MEMORANDUM

SUBJ: Action Memorandum - Approval for a Non-Time-Critical Removal Action at the

Lower Neponset Superfund Site, Boston and Milton, Suffolk/Norfolk County,

Attachment 2

Updated Figure 3
Total PCBs in Phase
1 Reach Sediment

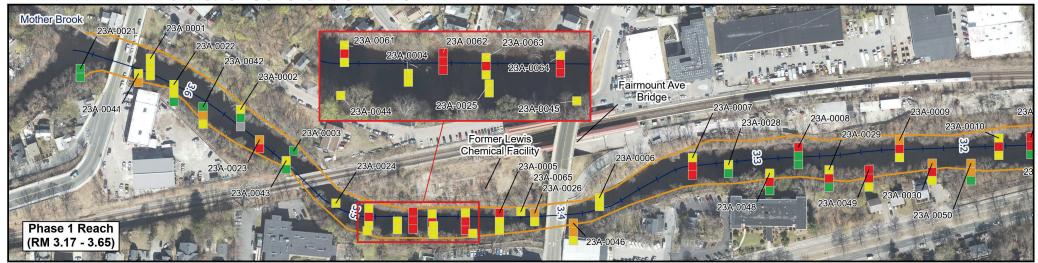
74. The commenters state the following: There are notable discrepancies between EPA's Site analytical data and visual representations of that data. Accurate communication of data is necessary for shareholders to make informed decisions. Figure 11 in the EE/CA Report are not consistent with analytical data presented in the EE/CA, or with analytical data and figures presented in the Phase 1 Data Summary Evaluation Memorandum.

During the public comment period for the Engineering Evaluation/Cost Analysis (EE/CA) for Phase 1 Reach of the Lower Neponset River Superfund Site, a commenter identified discrepancies in Figure 11 presented in the EE/CA Report. Following EPA's receipt of the comment, EPA and its contractor AECOM, which had generated the figures for the EE/CA Report, performed a thorough review of EE/CA Report figures to identify discrepancies, determine the cause of the discrepancies, and verify that any discrepancies did not impact the removal action alternatives (including the extent of the areas proposed for sediment and floodplain soil removal, volumes, and costs) or the evaluation of alternatives in the EE/CA. This memorandum details the results of the review, attaches updated EE/CA Report Figures, and confirms that the errors were limited to some of the EE/CA Report Figures and had no impact whatsoever on the data, the analyses presented in the EE/CA Report, or evaluation of the alternatives. This memorandum, with attachments, are included as Attachment 6 of the Action Memorandum for the Non-Time-Critical Removal Action.

AECOM looked into the source of the discrepancy between the representation of the PCB concentration in the surface sediment sample in Figure 11 of the EE/CA compared to similar surficial sediment concentrations represented in Figure 10 of the Data Summary Evaluation Memorandum. In short, ArcGIS Pro includes a data query toggle for each reported data interval at each location sampled. When a toggle is not activated, the logic in the program is to report the highest concentration interval in its place. There were locations reported on Figure 11, as well as Figures 3, 7, and 9, where the surface

At EPA's request, AECOM also completed an analysis of all EE/CA Report figures and Phase 1 Reach data to identify all errors across EE/CA Report Figures. AECOM reviewed all PCB data to ensure that the query toggle was activated and that all sample concentration representations on all figures are shown correctly. AECOM provided the results of its analysis in the attached Table. Further, EPA requested that AECOM provide updated figures of all EE/CA Report figures that contained errors. AECOM corrected errors to affected EE/CA Report Figures. Updated EE/CA Report Figures 3, 7, 9, and 11 are attached.

Updated Figure 11 RAA-4 Sediment Removal Areas

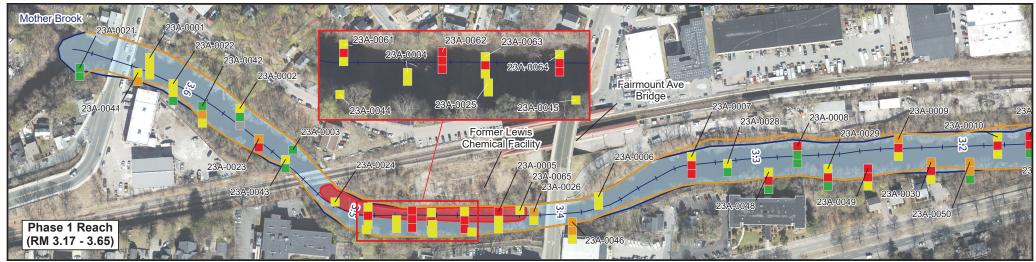
EPA requested that its AECOM determine the source of discrepancies identified in Figure 11 of the EE/CA Report and any additional discrepancies throughout EE/CA Report figures. AECOM provided the following response:
